# SERVICE BULLETIN

SERVICE BULLETIN NO: 24-019

## ELECTRICAL POWER - DC GENERATION SYSTEM SECOND GENERATOR CONTROL UNIT - REPLACEMENT

Revision 1 to this Service Bulletin changes the Part No. of the replacement GCU. GCU Part No. 988.21.15.102 is superseded by GCU Part No. 988.21.15.103.

Removal of Voltage Relay and Installation of GCU  
Figure 1

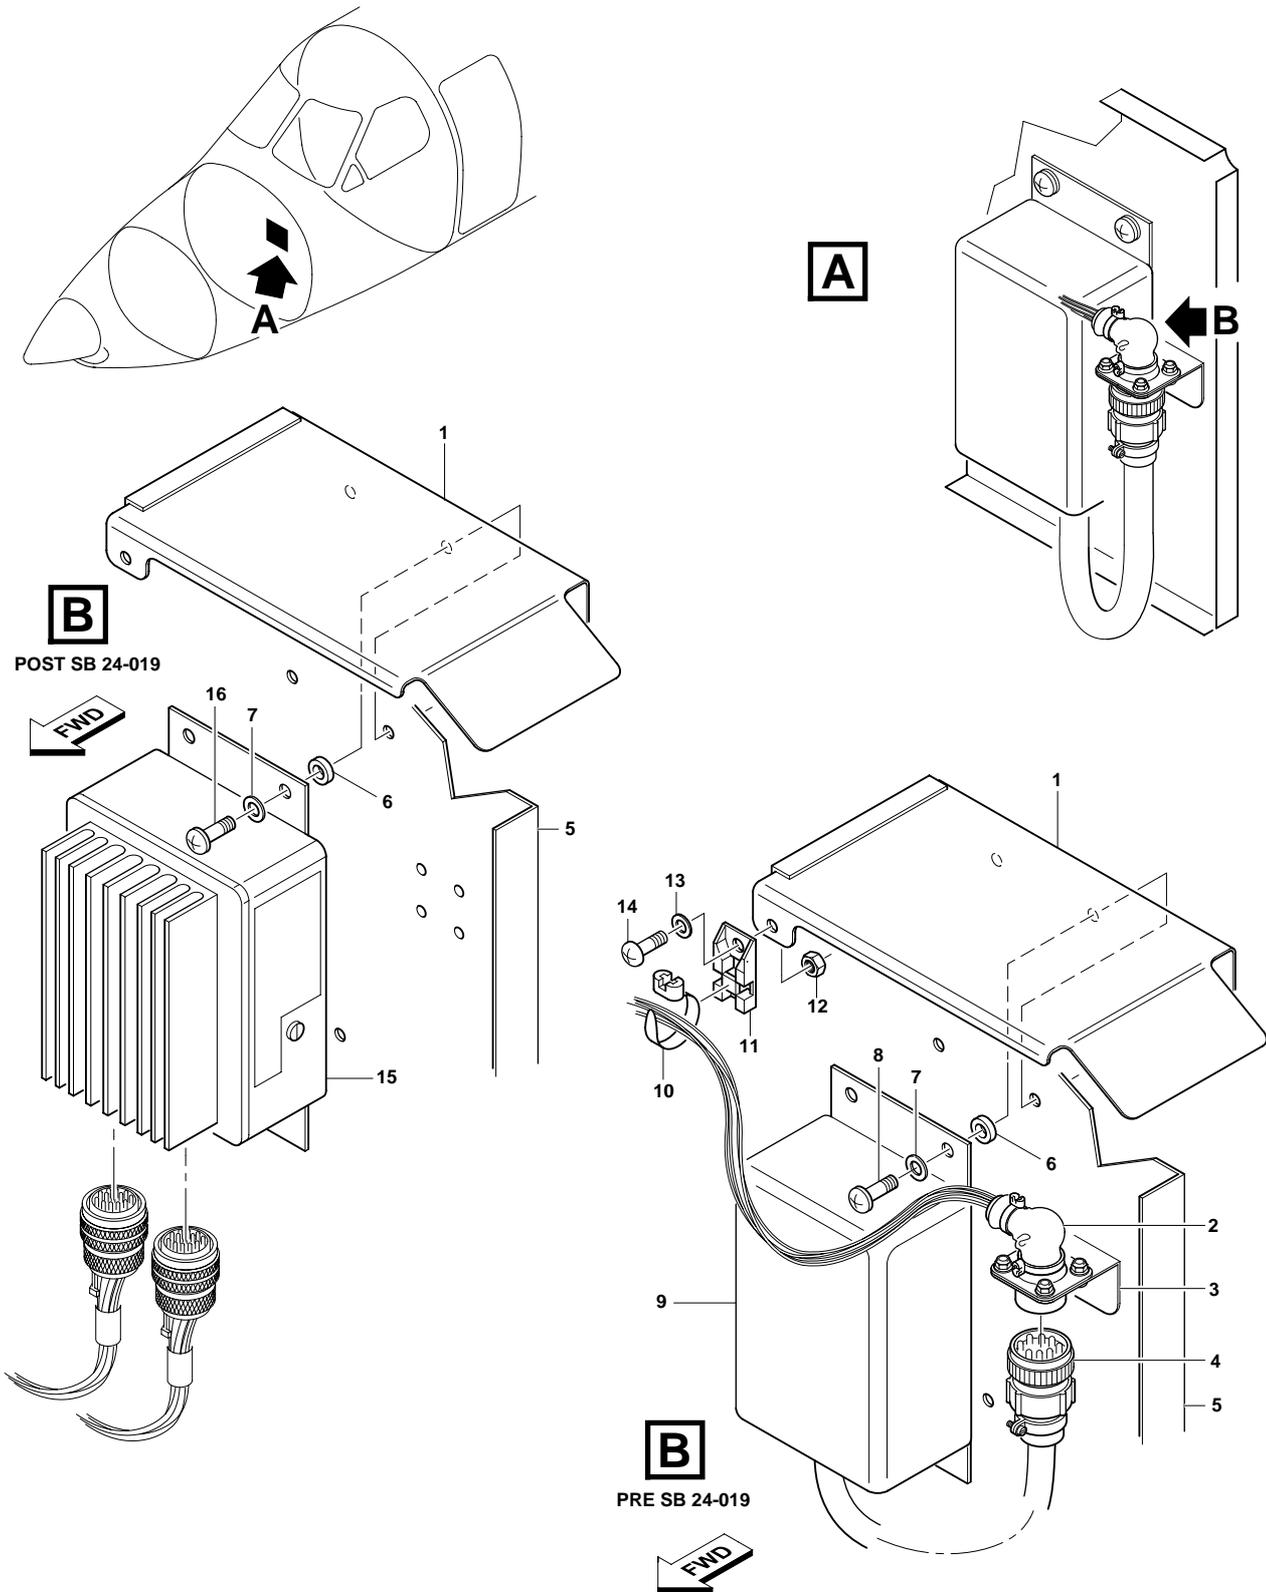
**B. Voltage Regulator and Related Components - Removal (Ref. Fig 1 and 2)**

- (1) Disconnect the connector (4) from the connector J233 (2).
- (2) Remove and discard the nut (12), washer (13), screw (14) holder (11) and cable tie (10) from the cover (1). This step is only applicable on post Service Bulletin 24-015 aircraft.

- (3) Remove the voltage regulator VR231 (9) (Ref. AMM, 24-30-06, Page Block 401). If applicable do this together with the cover (1). Discard the voltage regulator VR231, screws (8) and, if installed, the distance bushes (6).

- (4) Disassemble the connector J233 (2) from the bracket (3). Discard the connector.
- (5) Use the applicable diameter drill to remove the four rivets which attach the bracket (3) to the plate (5) (Ref. SRM, 51-40-01, Page Block 1). When you do this, hold a piece of steel sheet (or equivalent) behind the plate to give protection to the adjacent structure. Discard the bracket.

**C. GCU - Installation (Ref. Fig. 1, 3 and 4)**

- (1) Make sure the static bond area on the plate (5, Fig 1) is clean.
- (2) Assemble the GCU VR231 (15), three new distance bushes (6), washers (7) and new screws (16). If applicable, include the cover (1) when you do this.
- (3) Fully install the screws (16).
- (4) Install the stud (2, Fig 4).

Gen 2 Schematic (Pre-SB 24-019)  
Figure 2 (Sheet 2 of 2)

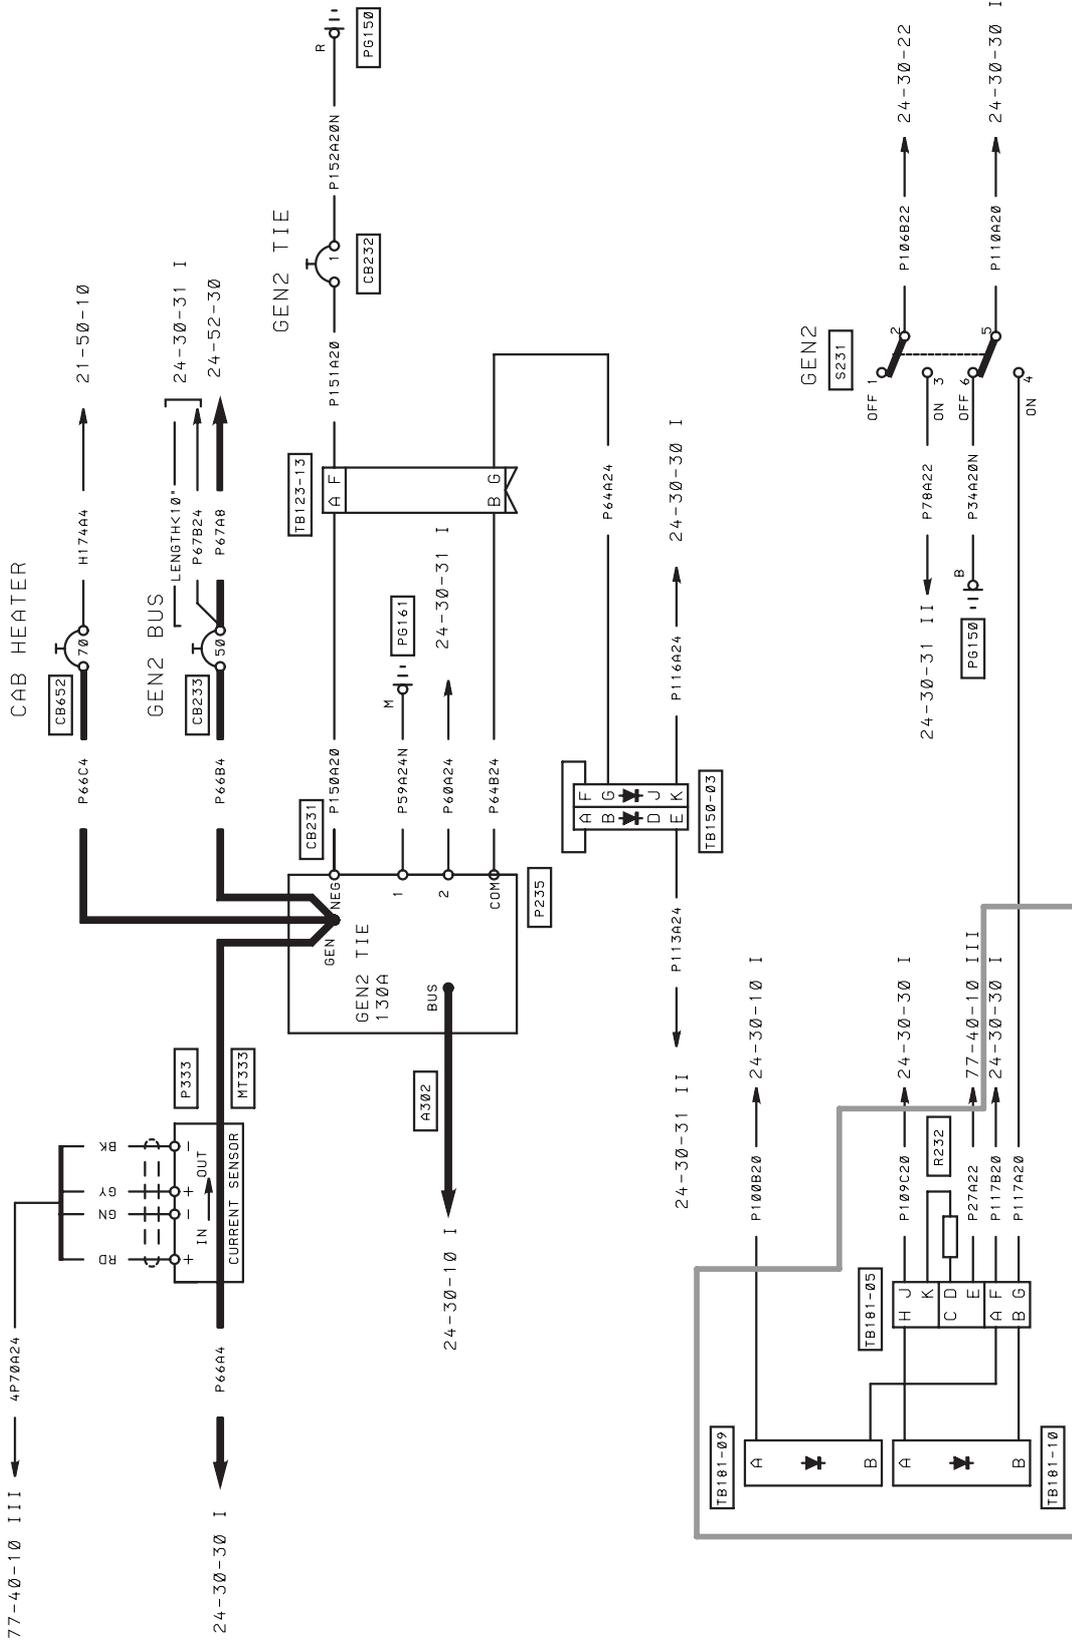
(8) Remove the electrical components (Ref. Fig 2 and Table (Wire/Cable - Removal)).

(a) Disconnect or remove the wires as specified.

Wire/Cable - Removal			
Wire	Terminal/Connector	Terminal/Connector	Remarks
AWG20	A250 POS	K234, pin 6	Remove and discard
AWG20	A250, NEG	PG090 pin H	Remove and discard
AWG20	K231, 1	CB234	Remove and discard
AWG20 (Link)	TB181-05, pin A	TB181-09, pin B	Remove and discard
AWG20 (Link)	TB181-05, pin B	TB181-10, pin B	Remove and discard
AWG20 (Link)	TB181-05, pin H	TB181-10, pin A	Remove and discard
P100B20	TB181-09, pin A	N/A	Disconnect at specified end
AWG20 (Link)	TB093-01, pin G	TB093-02, pin A	Remove and discard
P109A20	CB234	TB093-01, pin C	Remove and discard
P109B20	PB002, pin U	TB093-01, pin E	Remove and discard
P109D20	K233, pin 7	TB093-01, pin D	Remove and discard
P109E20	K233, pin 2	CB234	Remove and discard
P110B20	PB002, pin X	TB093-01, pin F	Remove and discard
P110C20	K234, pin 3	TB093-01, pin A	Remove and discard
P110D20	J233, pin C	TB093-01, pin B	Remove and discard
P111A20	K234, pin 8	TB093-02, pin B	Remove and discard

P111B20	G231, D+	K234, pin 4	Remove and discard
P112A20	J233, pin J	K234, pin 2	Remove and discard
P117B20	JB002, pin Y	TB181-05, pin F	Disconnect at each end (Cap and stow)
P117C20	PB002, pin Y	K234, pin 7	Remove and discard
P118A20N	K233, pin 3	J233, pin G	Remove and discard
P119A20	K233, pin 4	K231, pin A	Remove and discard
P120A20N	PG090 pin H	K234, pin 5	Remove and discard
P27A22	TB181-05, pin E	N/A	Disconnect at specified end
P29A20	J233, pin B	N/A	Disconnect at specified end
P65B22	J233, pin A	N/A	Disconnect at specified end
P68A20	J233, pin K	N/A	Disconnect at specified end
P69A20N	P29A20	PG090 pin M	Remove and discard
P71A20N	J233, pin L	G231, B-, GND	Remove and discard
P79C22	P231, pin D	PB002, pin S	Remove and discard
R232	TB181-05, pin K	TB181-05, pin D	Remove and discard

- Relays (K233) and (K234)
- Suppression filter (A250)
- Terminal block assemblies (TB093-01, TB093-02 and TB181-09/10)
- Circuit breaker (CB234)

Gen 2 Electrical Connections and Terminals (Post SB 24-019)  
Figure 4

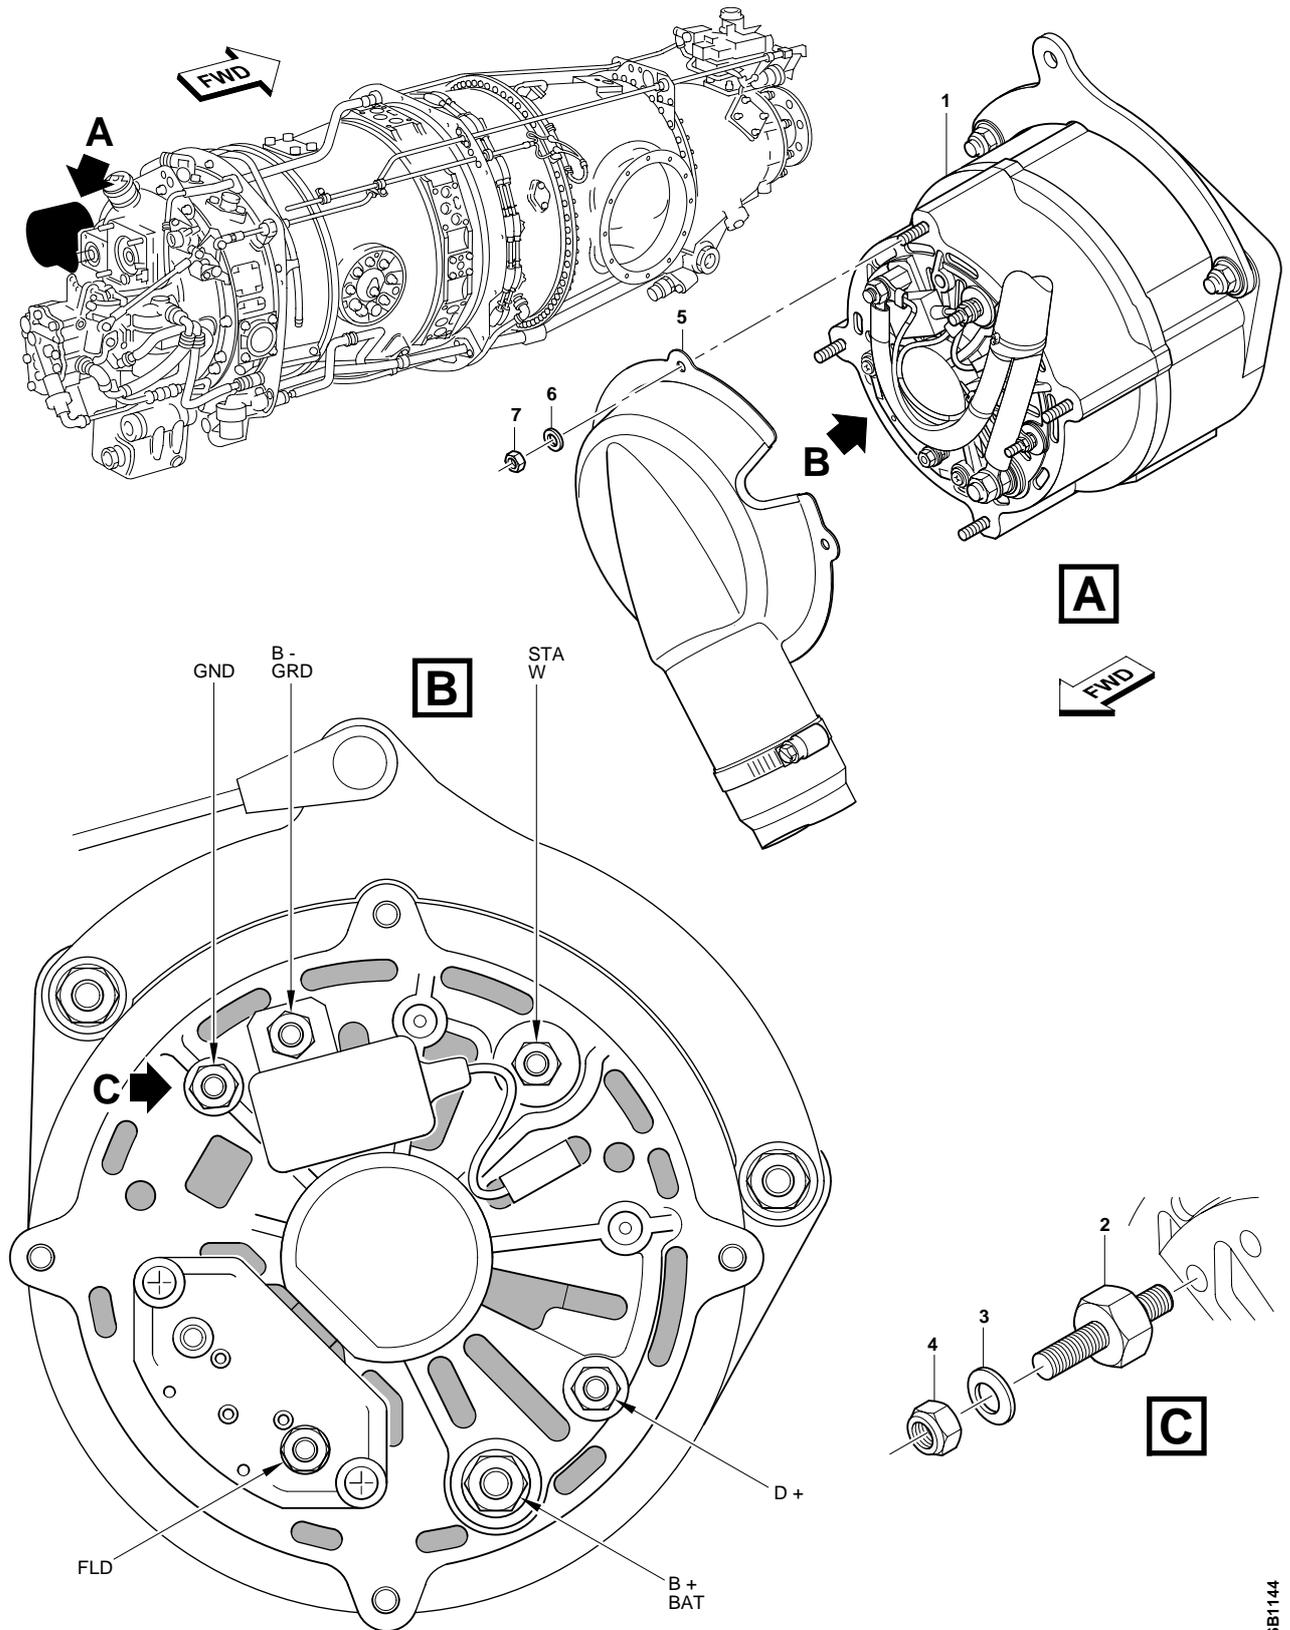
- (6) Obey the manufacturers instructions and apply layers of corrosion preventative (Item No. P07-001) on the bare surfaces of the open rivet holes.
- (7) Remove the three nuts (7, Fig. 4), washers (6) and the cover (5) from the Second Generator (1).

**NOTE:** The nut (4) and washer (3) are supplied with the stud (2) as an assembly.

- (a) Obey the manufacturers instructions and apply a thin layer of the adhesive (Loctite 270 or equivalent alternative). Do this on the threads of the hole in the GND position on the housing of the Second Generator (1). Remove unwanted adhesive from the surfaces of the housing adjacent to the hole.
- (b) Make sure that the applicable (faying) surfaces are clean and dry (to make good electrical contact) around the:
  - Hole in the GND position on the housing of the Second Generator (1)
  - Hexagonal part of the stud (2)
- (c) Install the shorter threaded part of the stud (2) in the GND position on the housing of the Second Generator (1).
- (d) Torque the stud (2) to 25.0 lbf in. (2,8 Nm) (Ref. AMM, 20-20-01, Page Block 1).
- (5) Assemble and Install the cable assemblies and wires (Ref. Fig. 3, 4 and the Table (Wire/Cable - Assembly and Installation)).

- (6) Put the cover (5) in position on the Second Generator (1) and install the washers (6) and nuts (7).
